Office Action Summary

10/578,028

DETAILED ACTION

FIG.3

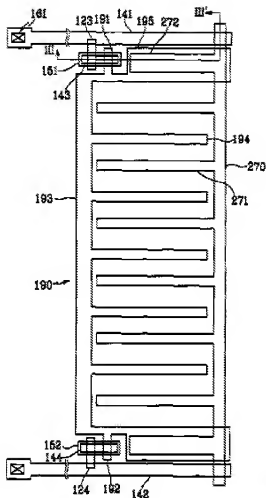
Oh et al disclose (Figs. 2 and 3) a thin film diode array panel comprising:

- an insulating substrate (110)
- first redundant gate lines (141) including a first input electrode (123) and made of an opaque conductor
- second redundant gate lines (142) including a second input electrode (124) and made of an opaque conductor
- first and second contact electrodes (191 and 192) formed on the insulating substrate and made of an opaque conductor

- an insulating layer (151, 152) formed on the first and second input electrodes and the first and second contact electrodes
- a first floating electrode (143) formed on the insulating layer (151) and overlapping the first input electrode (123) and the first contact electrode (191)
- a second floating electrode (144) formed on the insulating layer (152) and overlapping the second input electrode (124) and the second contact electrode (192)
- a pixel electrode (190) connected to the first and second contact electrodes

Oh et al lack disclosure of a first gate line formed at least partially directly on the first redundant gate line; a second gate line formed at least partially directly on the second redundant gate line.

- wherein the insulating layer includes a first insulating layer (151) regionally formed around the first floating electrode (143) and a second insulating layer (152) regionally formed around the second floating electrode (144)

- wherein the insulating layer (151, 152) covers the first and second redundant gate lines (141 has a protruding portion/input electrode 123 and 142 has a protruding portion/input electrode 124) and the first and second contact electrodes (191, 192)
